PERMIT

SEWAGE DISPOSAL SYSTEM

MARYLAND STATE DEPARTMENT OF HEALTH

SUBDIVISION ROAD 10818 Hunting Lane LOT

PERMIT CARD

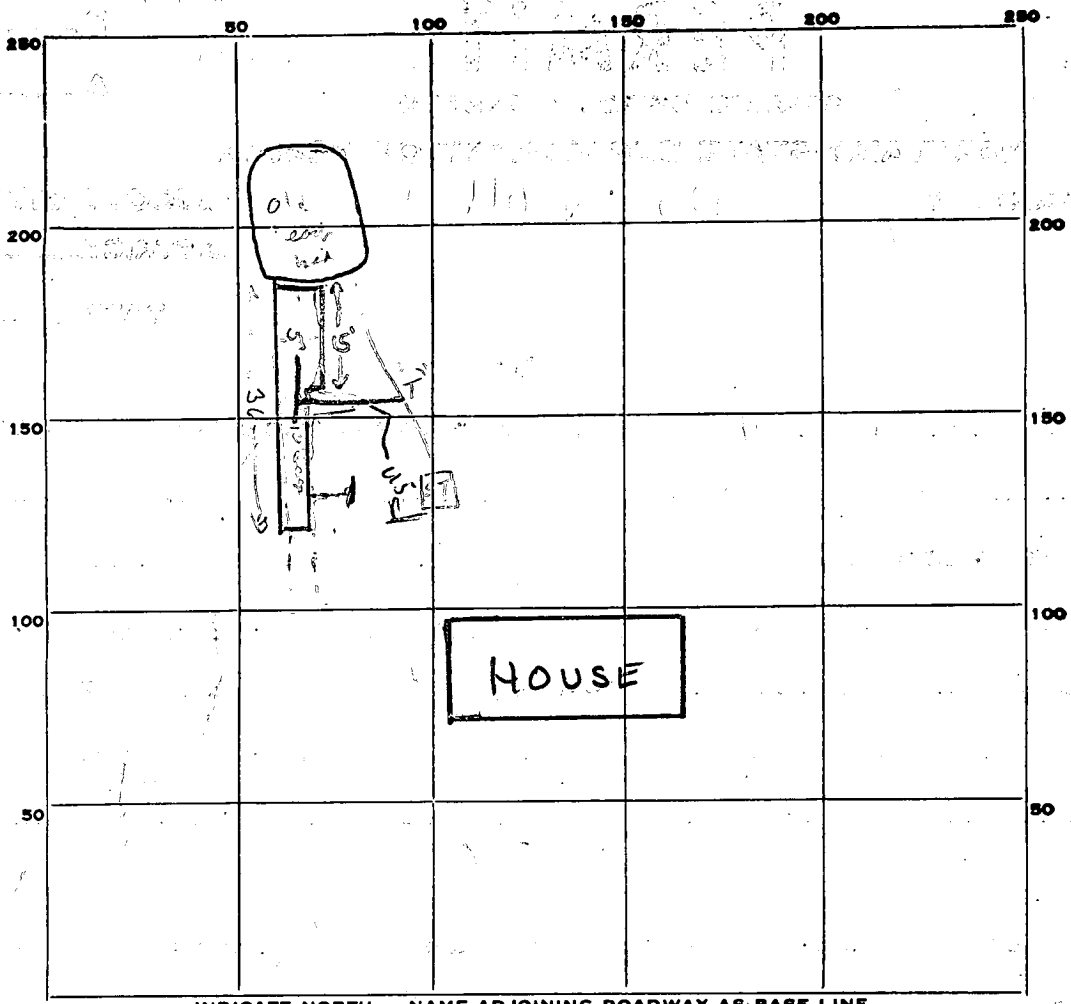
REMARKS 11/16/77 Barth & owner Utterback on site, old leach bed found, ~7-8 ft deep, O.K. to tie into line before leach bed & start new 50 ft trench & wide trench or pit at far end due to caving problem. also O.K. to grade trench as it is up providing Utterback records depth - max depth to be 10 ft N.S.

11/16/77 20 ft of trench still needed N.S. 27 Feb 79 - System backfilled - excavation for trench approx. 50' long - NO ONE HOME. (GLK) Approved per DM

DATE SYSTEM APPROVED 6 Mar 79 INSPECTOR G. Keller

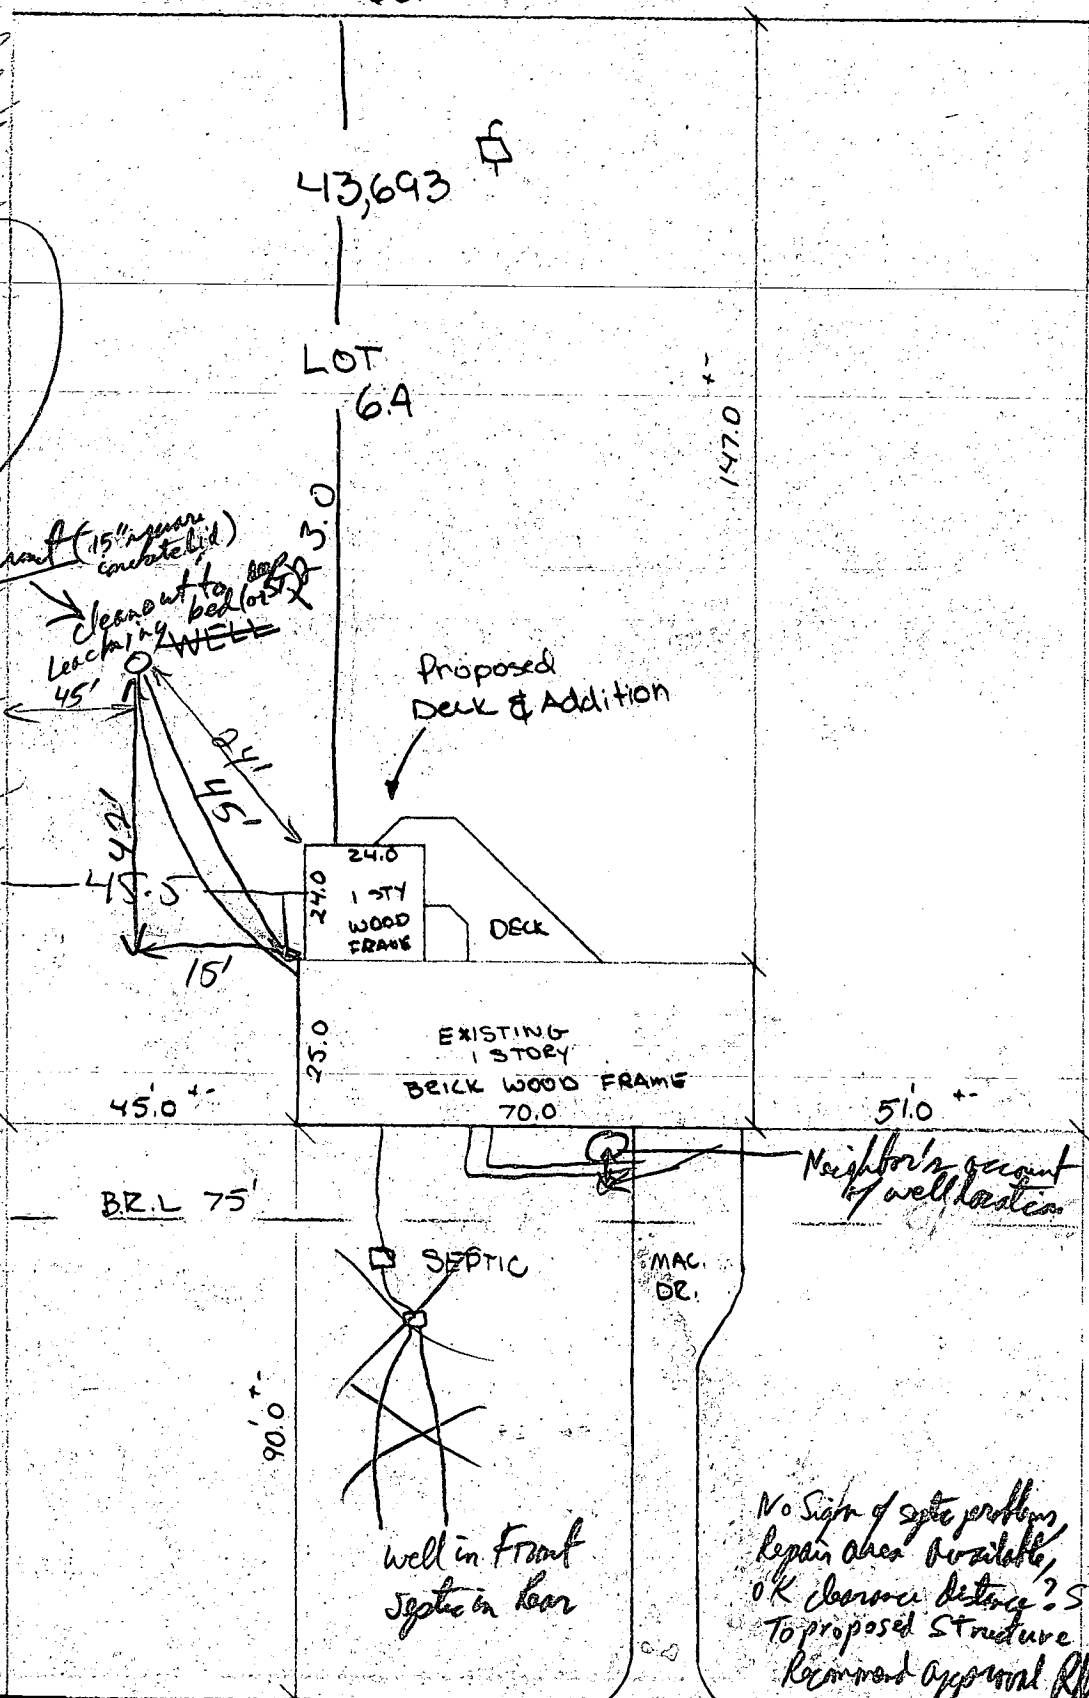
see top in permit (15" in rear concrete lid)
Pg 6559 N
(8/15/99)
Clean out for
leaching bed
45'

No signs of septic problems, repair area available, OK clearance distance? ST? To proposed structure Recommend approval R/P 6/30/92
